Index 711-003 Interchange Markings

COMMENTARY

COMMENTS AND RESPONSES

TYPICAL PAVEMENT MARKINGS AT ENTRANCE RAMPS

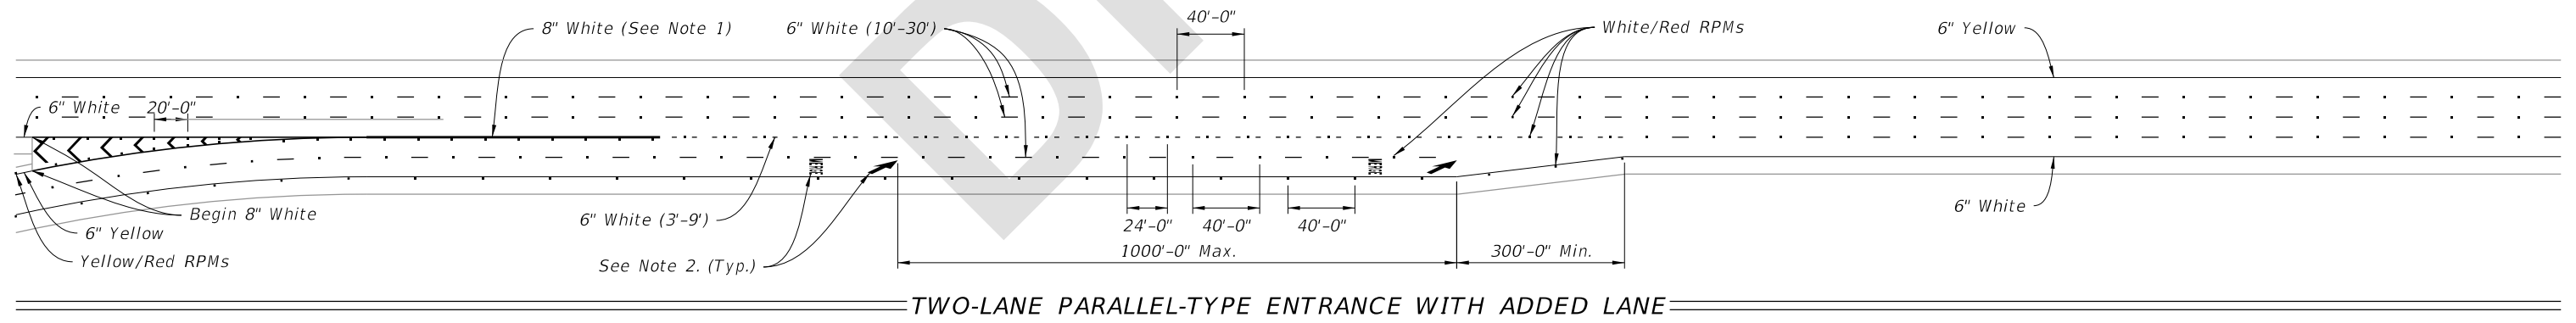
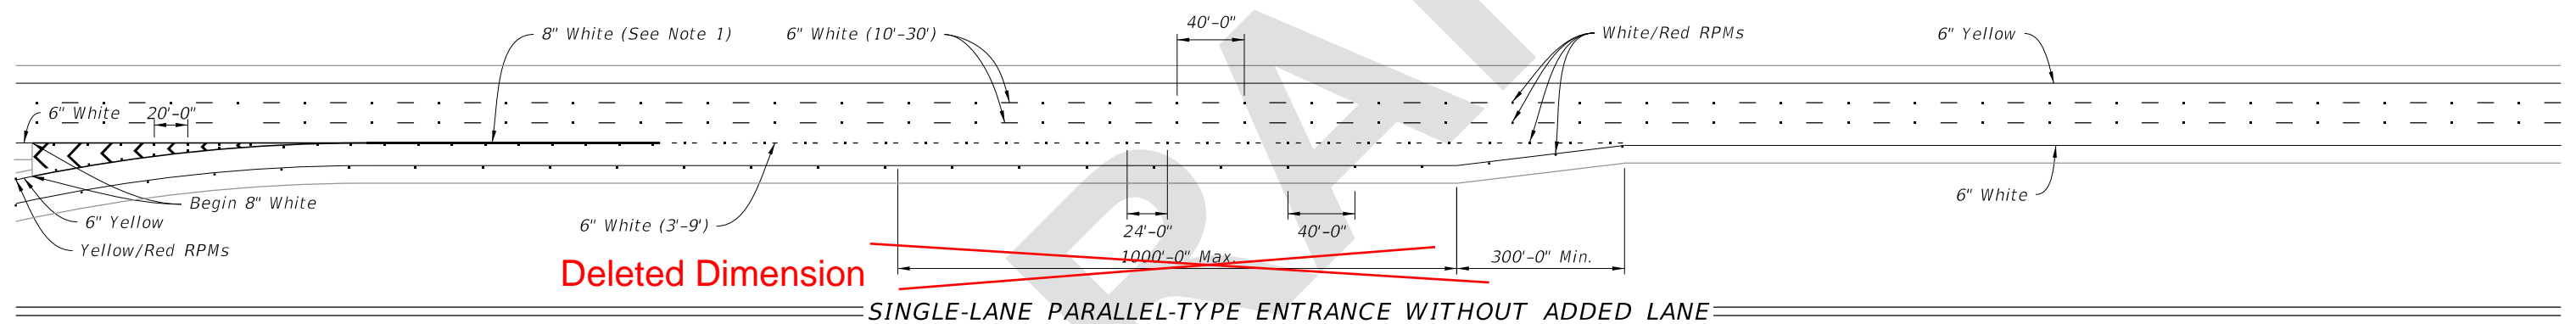
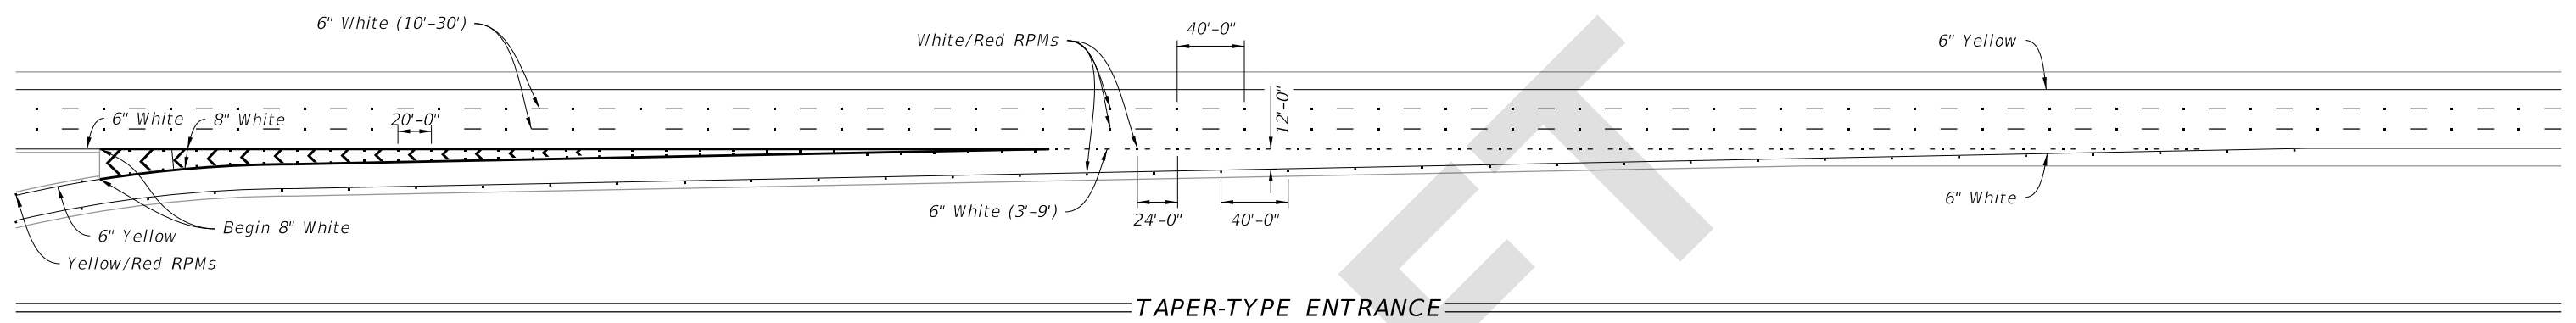
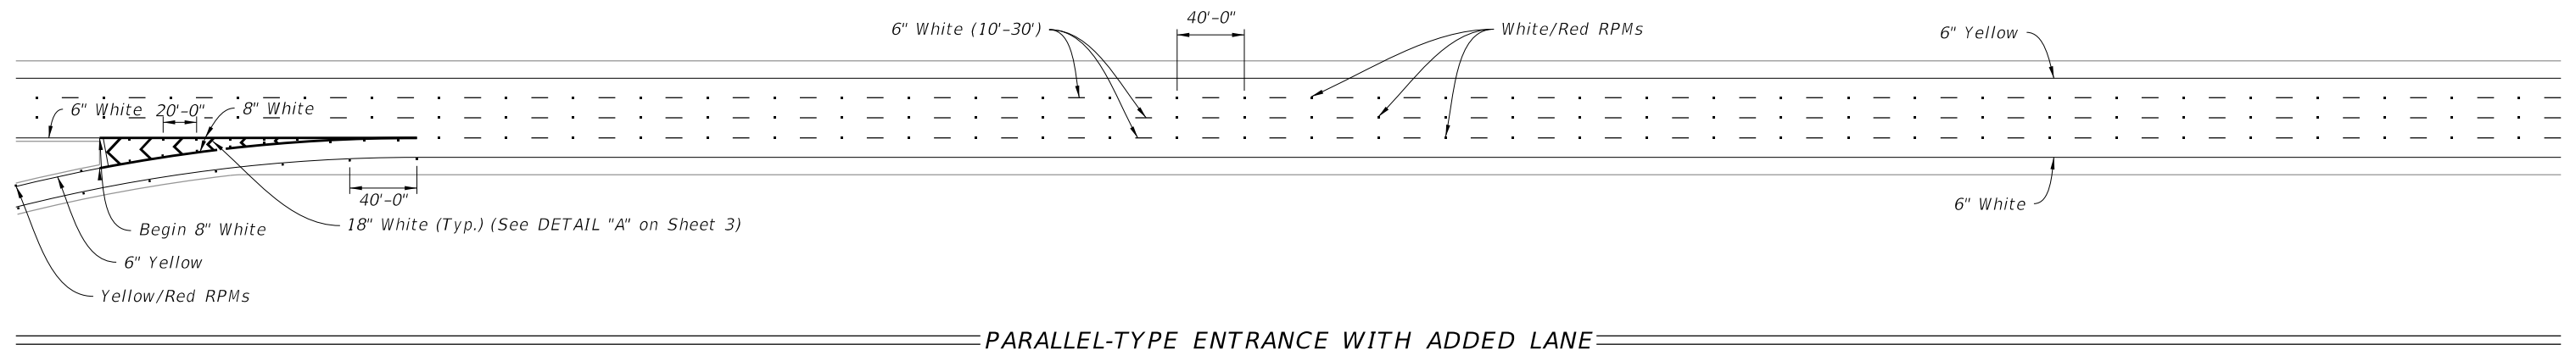
COMMENT: Is the new detail (SINGLE-LANE PARALLEL-TYPE ENTRANCE WITHOUT ADDED LANE) missing "MERGE" pavement markings?
What is the 1000'-0" measured to?

RESPONSE: Note 3 covers that only the "Two-Lane Entrance" uses the Merge Pavement Message and Arrow.

The 1000' Dimension in the Single-Lane Entrance should be deleted.

CHANGE MADE TO INDEX: Yes. The 1000' Dimension was deleted.
